## HISTORIC AND DESIGN REVIEW COMMISSION

February 02, 2022

**HDRC CASE NO:** 2022-030  
**ADDRESS:** 317 E MYRTLE  
**LEGAL DESCRIPTION:** NCB 1746 BLK 001 LOT 5 & E 25 FT OF 4  
**ZONING:** MF-33  
**CITY COUNCIL DIST.:** 1  
**DISTRICT:** Tobin Hill Historic District  
**APPLICANT:** Kyle Brooks/Integrated Outdoor Designs  
**OWNER:** Richard Armendariz  
**TYPE OF WORK:** Installation of rooftop deck  
**APPLICATION RECEIVED:** January 05, 2022  
**60-DAY REVIEW:** Not applicable due to City Council Emergency Orders  
**CASE MANAGER:** Katie Totman  
**REQUEST:**

The applicant is requesting a Certificate of Appropriateness for approval to install a railing and decking on the second-floor porch roof of the primary structure.

ORIGINAL FRONT  
ELEVATION OF HOUSE  
Prior to RENOVATION

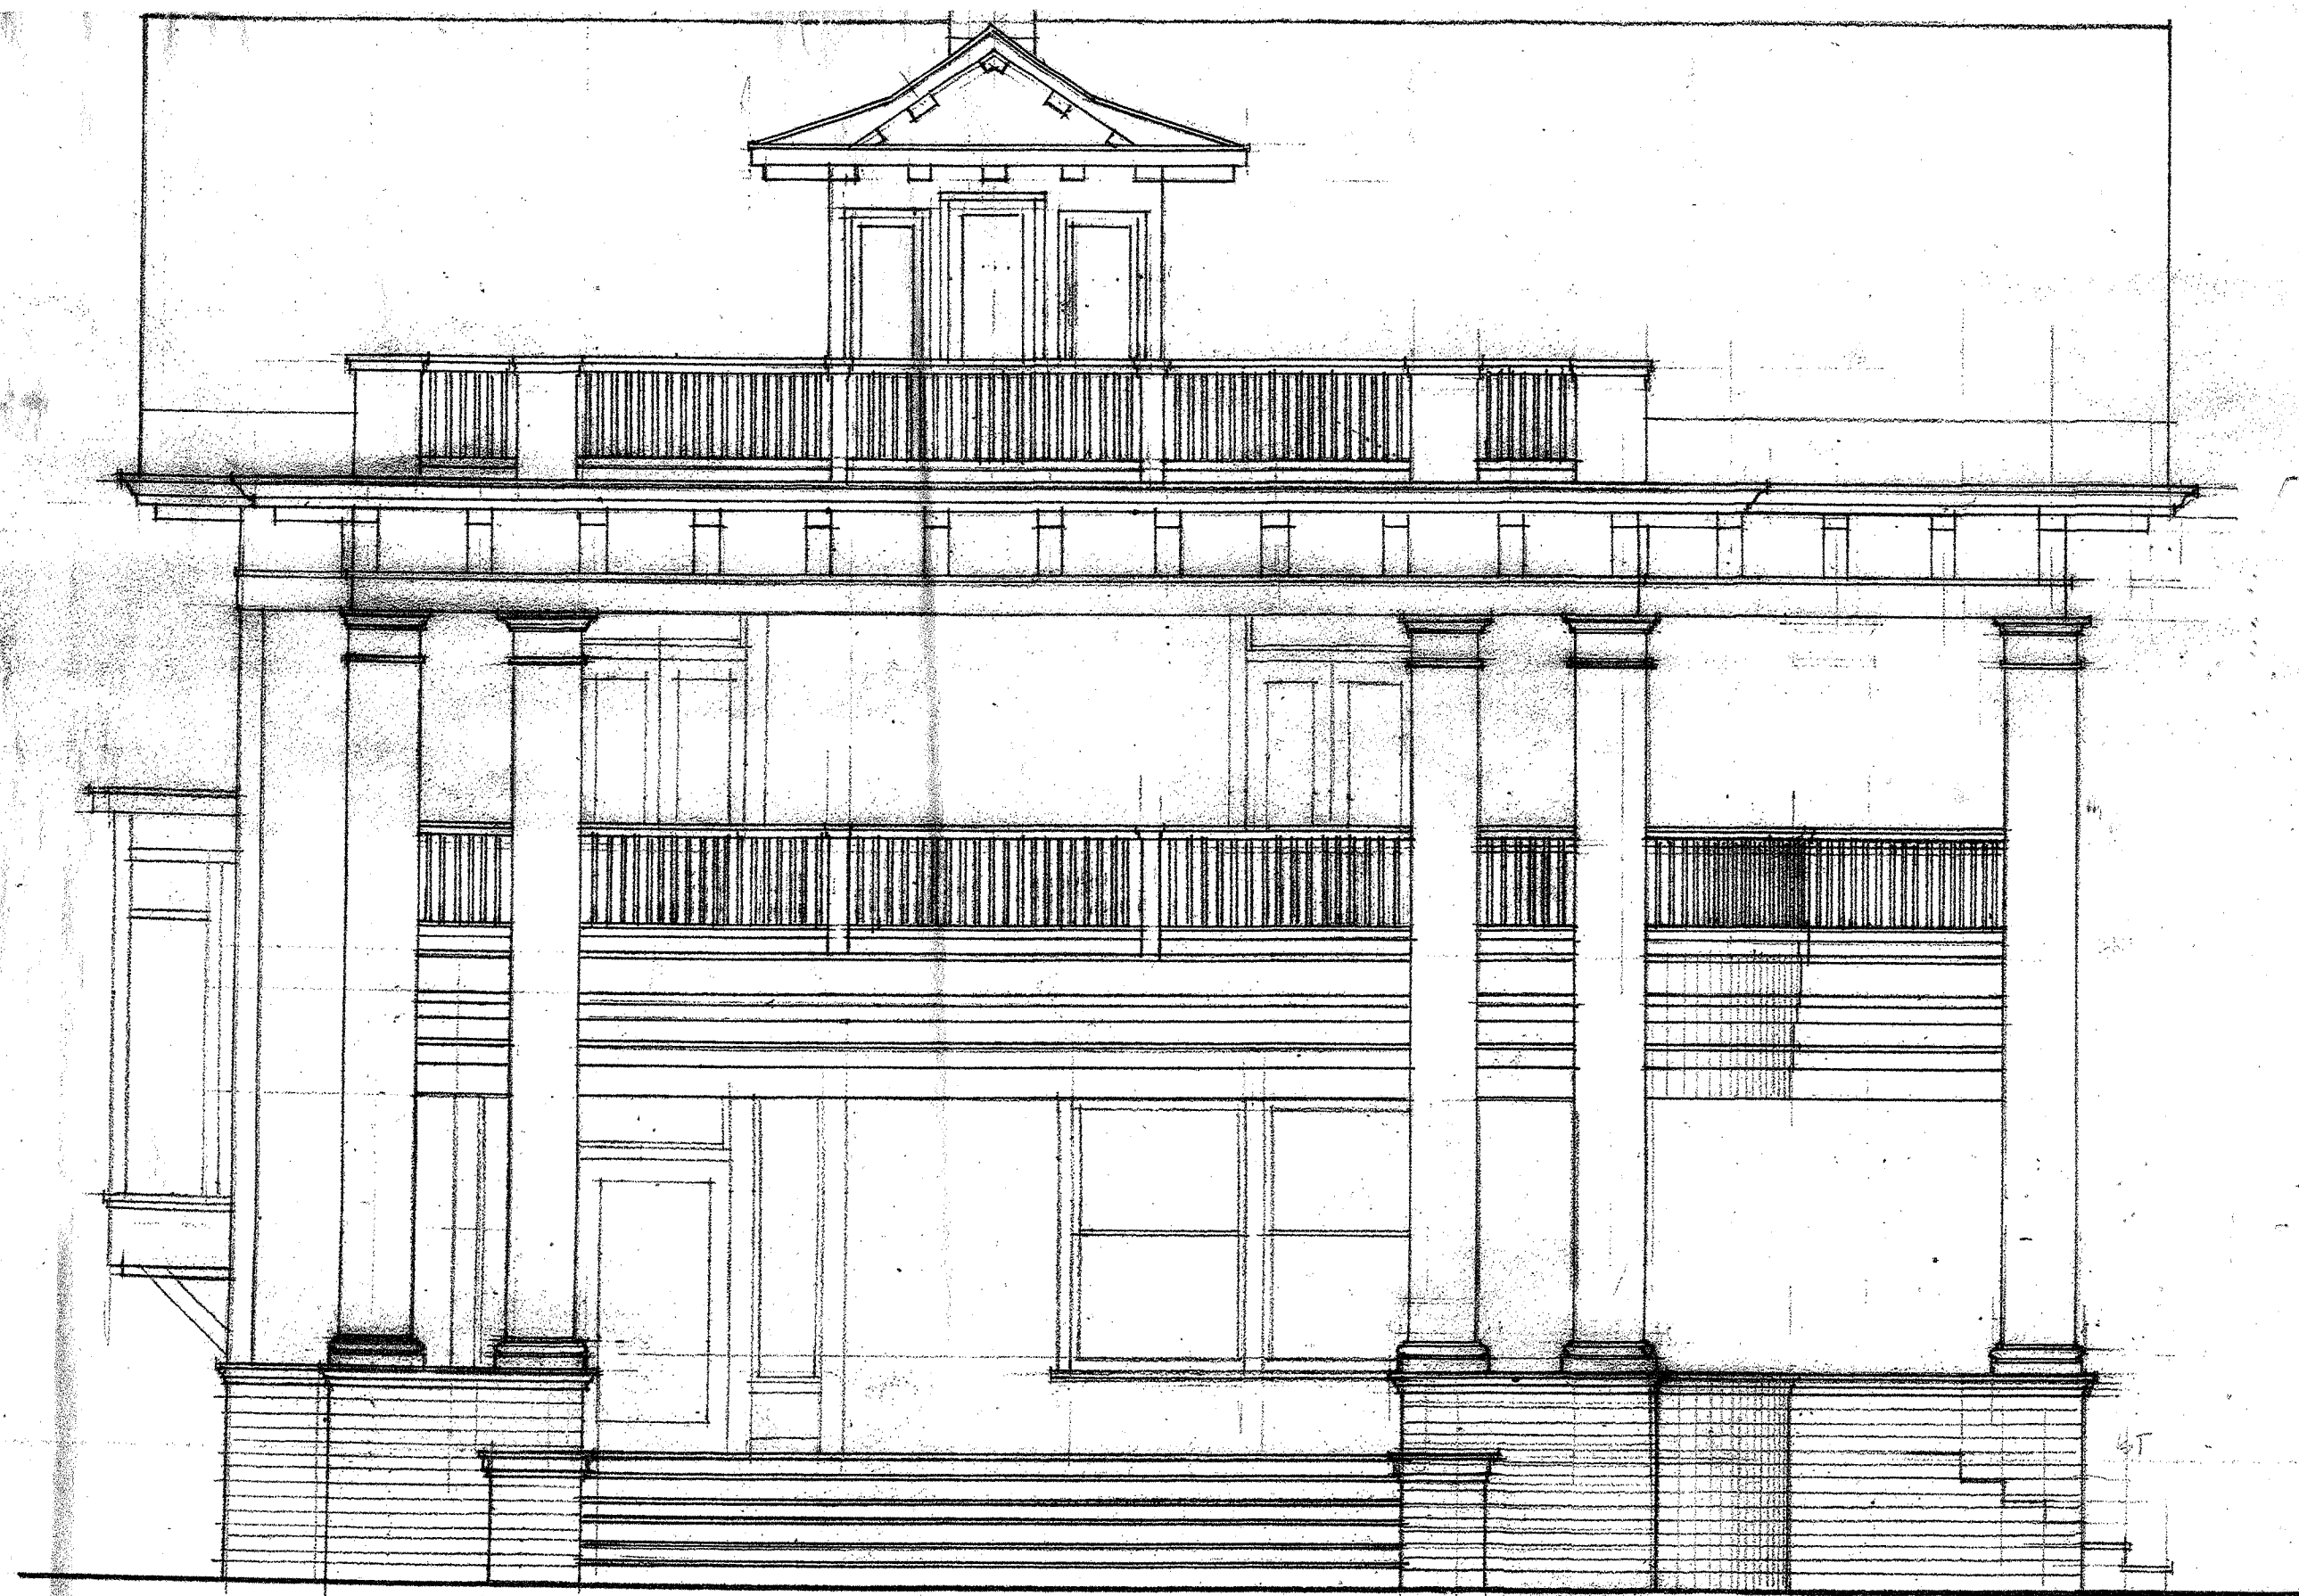
- b. **HISTORIC EVIDENCE** – The applicant has provided an old photograph of the house that shows a previously installed roof top railing. Staff also observed in the provided current photographs existing low columns on the second-floor porch roof that may be evidence of a previously existing porch railing.

Staff recommends approval based on finding b and c.

PROPOSED DECK + FRAME PLAN

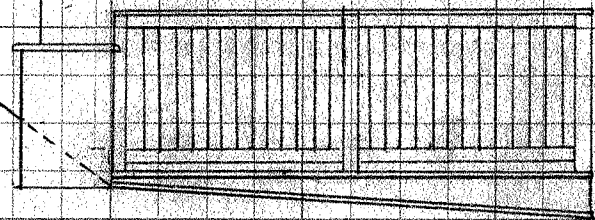
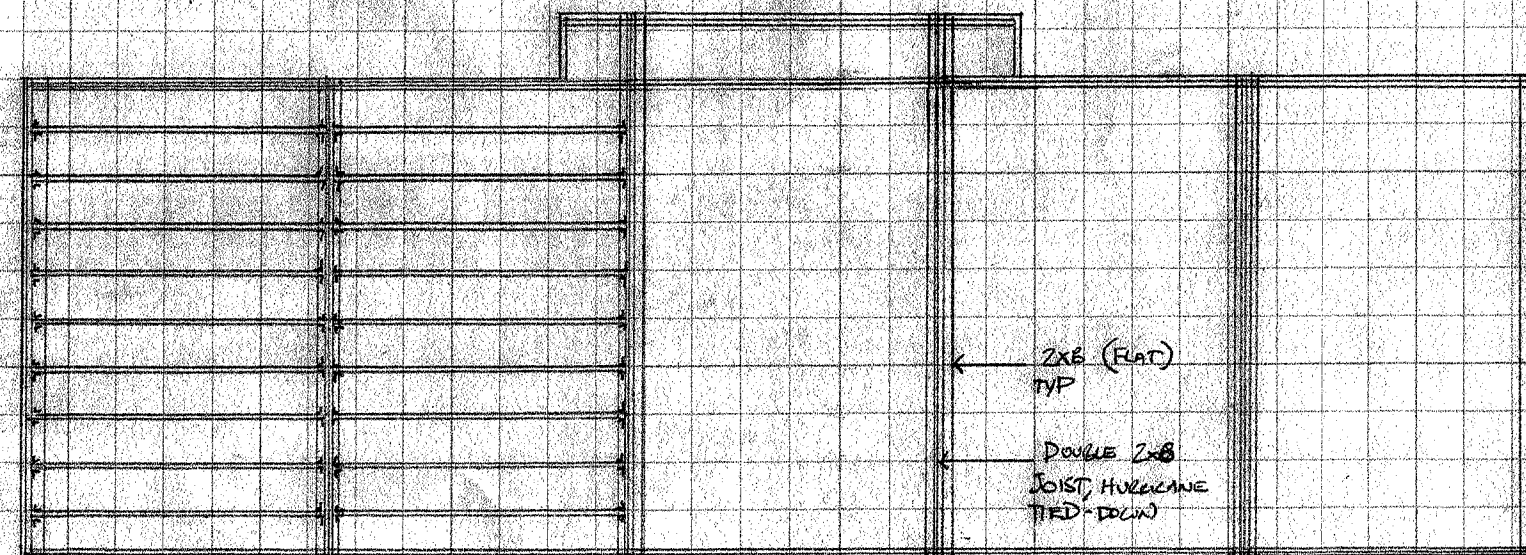
- c. **ADDITION OF THIRD STORY RAILING/DECKING** – The applicant has proposed to install a wood railing and Azek porch boards on top of the second-floor porch roof. The railing will be 42-inches tall feature a traditional cap on top of the spindles. Per the historic design guidelines for exterior alterations and maintenance 7.B.iv. and v., design replacement elements to be simple so as not to distract from the historic character of the building, and reconstruction of elements should be based on accurate evidence of the original, such as photographs. As noted in finding b the applicant has provided a historic photograph of the home with a railing installed in the proposed location. Staff finds that the request to reconstruct this feature is consistent with the guidelines.
